Flight Procedures Cover Page	Task Action: FLIGHT CHECK	Task Type: IAP	Estimated Chart Date: 03/19/2026	APWS Task ID: D9731B46287E4178B1395D32D238BCD6	APWS Project ID: 995F990A29E24DEA9E648BFBB668CBD
Procedure: RNAV (GPS) RWY 27R AMDT 2		Enroute: NO	Specialist: Ferreira, Giorgia		Agreement Number:
Airport ID: KPHL			Airport City: PHILADELPHIA		State: PA
Facility ID:	Facility Type:	Flight Inspection Remark Type: New FC Slot

RNAV (GPS) RWY 27R

PHILADELPHIA INTL (PHL)

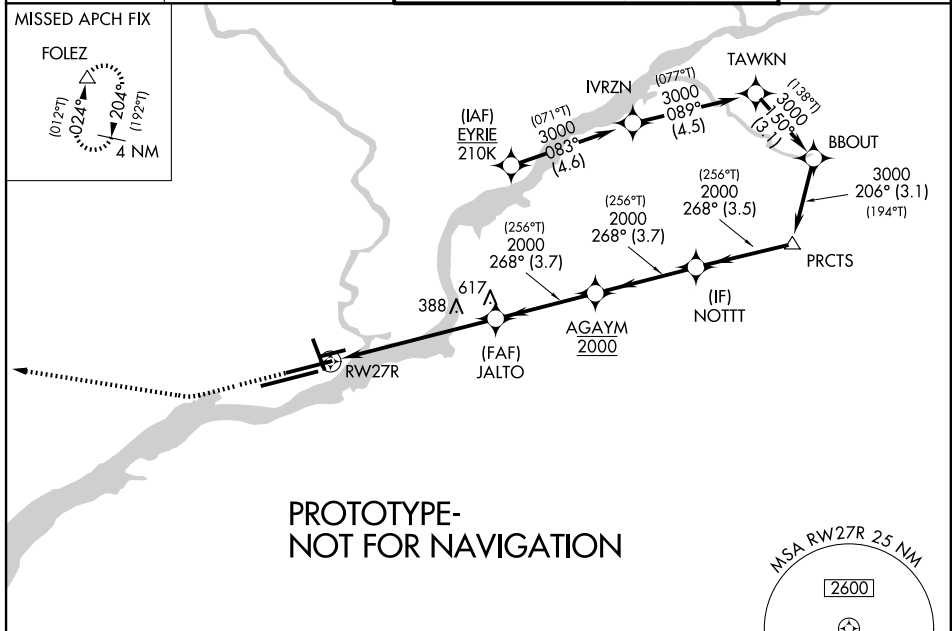
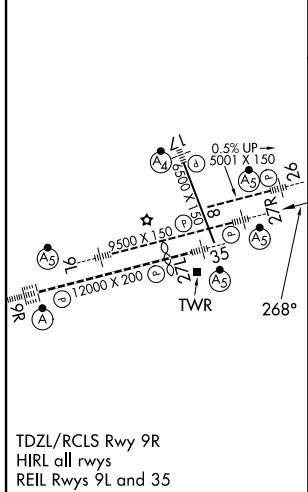
WAIVER REQUEST - REQUESTING APPROVAL TO CHART MANDATORY ALTITUDES IAW 8260.19J, 8-6-11.N(1).
ACTIVE AIRPORT AND RUNWAY DATA USED.

Request approval to chart mandatory altitudes at the KPHL RNAV (GPS) RWY 27R intermediate fix (IF), and the intermediate step-down fix.

1. Prevent aircraft executing the approach from entering airspace delegated to other sectors and facilities.
2. Keep aircraft separated from nearby airport traffic.
3. The mandatory crossing altitude at AGAYM is needed for separation and to deconflict from traffic landing RWY 27L, that is being stepped down by controllers 1000 feet above traffic landing RWY 27R, until visual separation can be applied between the two aircraft.

1. The mandatory altitude set at BBOUT and PRCTS ensures level flight prior to NOTTT.
2. Adequate distance has been provided for aircraft to achieve the mandatory altitude at AGAYM.

The use of at or above altitudes at the fixes does not provide the necessary separation required for the congested airspace.
